**ADDENDUM NUMBER:**           **THREE (03)**

**ADDENDUM DATE:**           **November 13, 2018**

**PROJECT:**                   **New Employee Housing and New Garage  
Black Lake and Stony Rapids, Saskatchewan**

# FOUNDATION PLAN

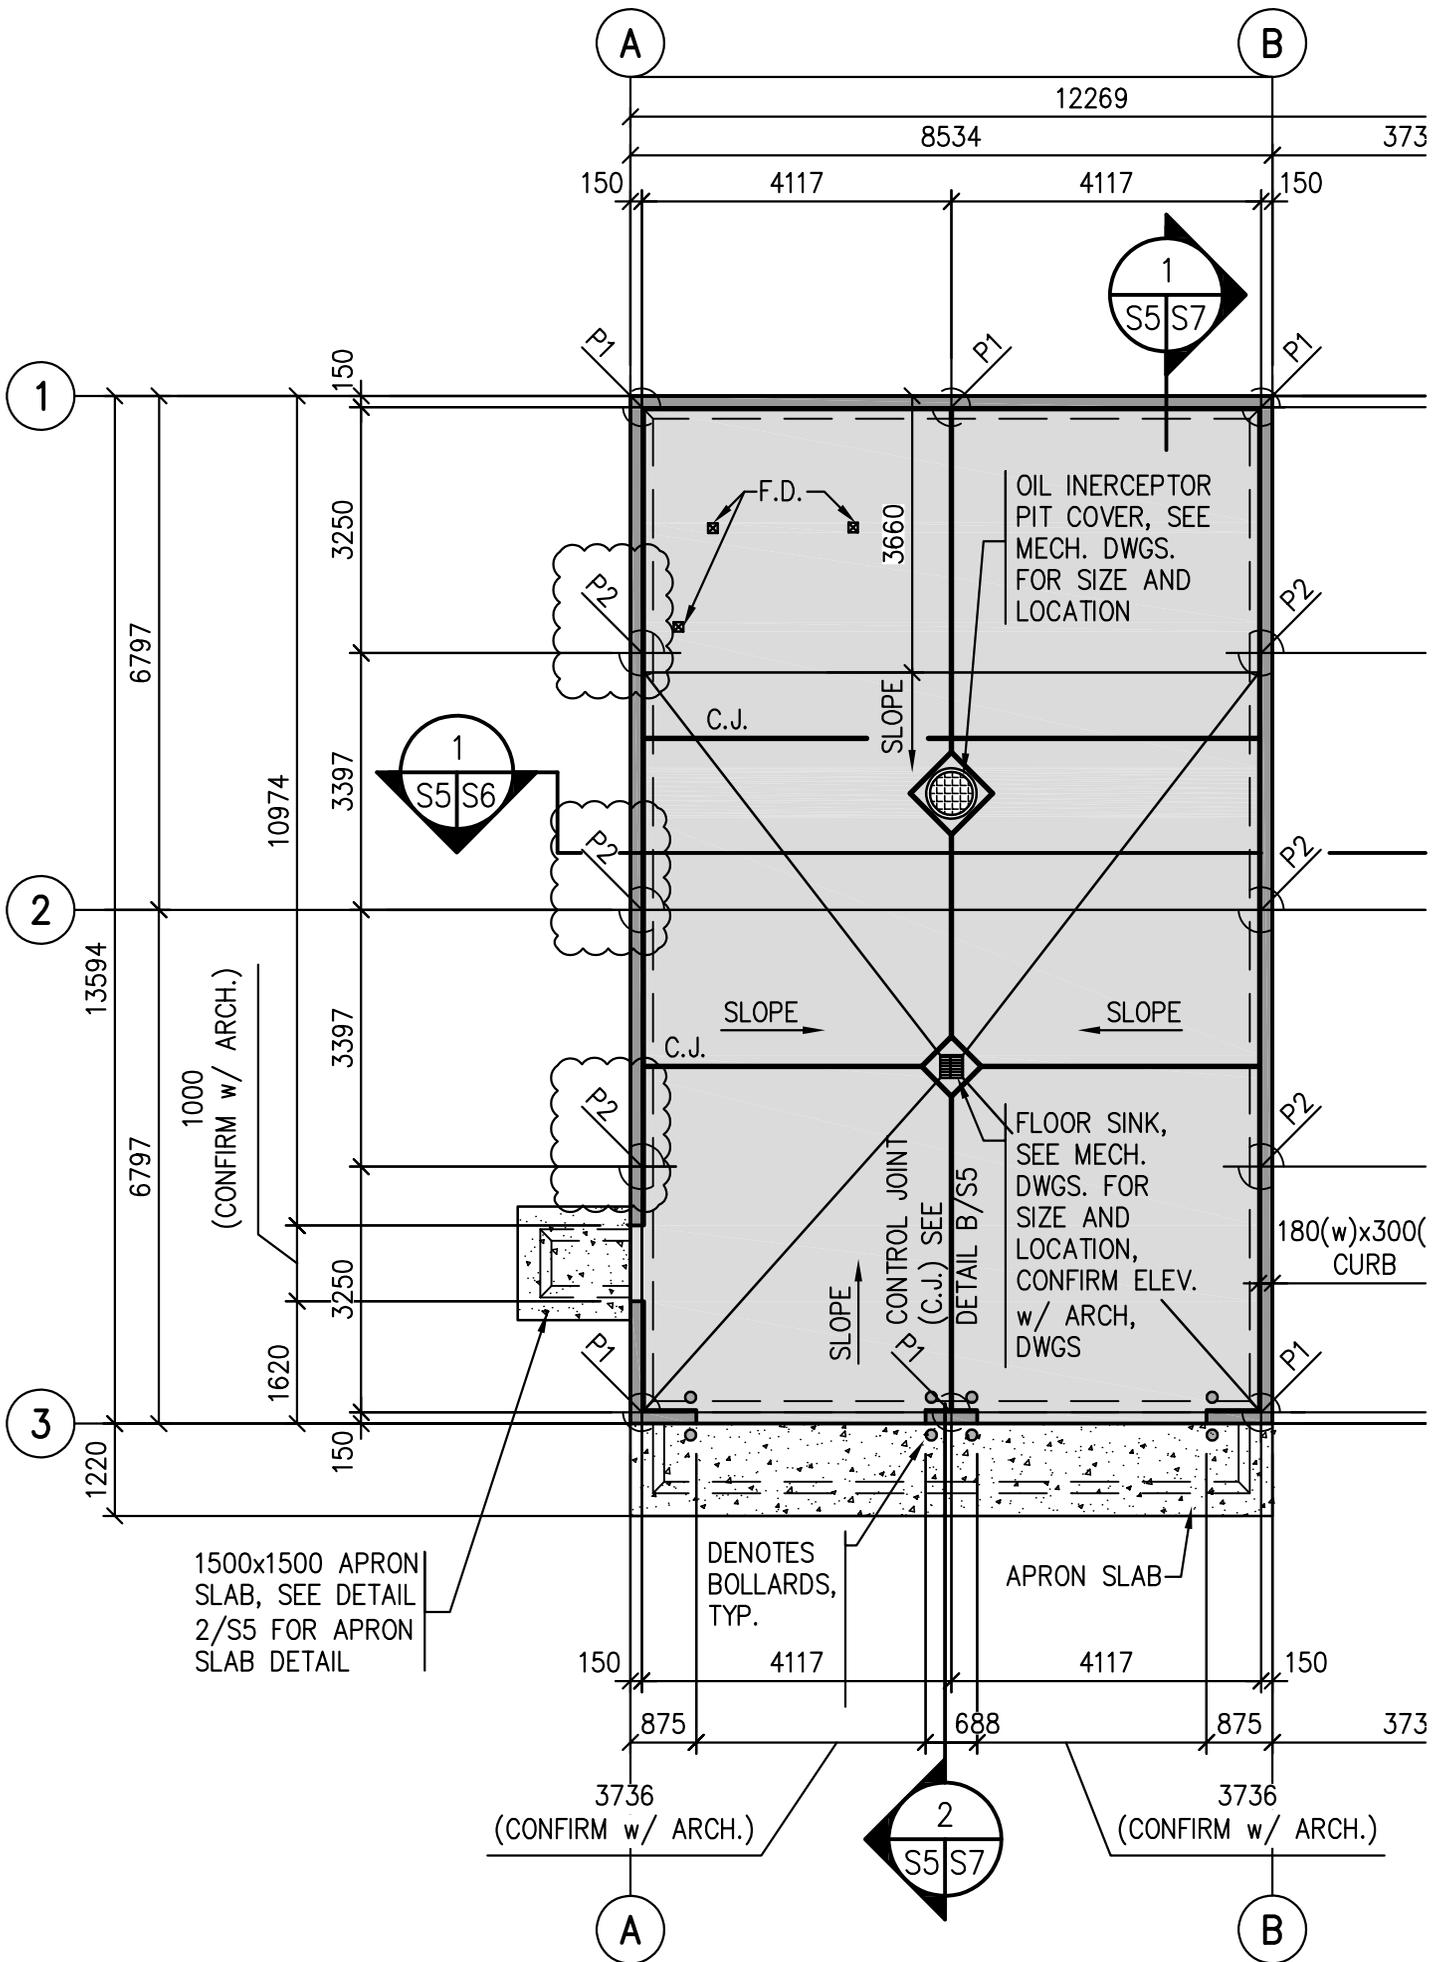
- .2 **Q:** Detail 1 Drawing S5 shows three P1 piers between gridline 1 and 3 on the west side, however, they look to be P2 piers. Please clarify.  
**A:** See below S-3-1 for clarification.

1. Refer to drawing S5 detail 1/S5. Revise the three piles between grids 1 and 3 along grid A from P1's to P2's. See the attached sketch 1/SK2 for clarification.
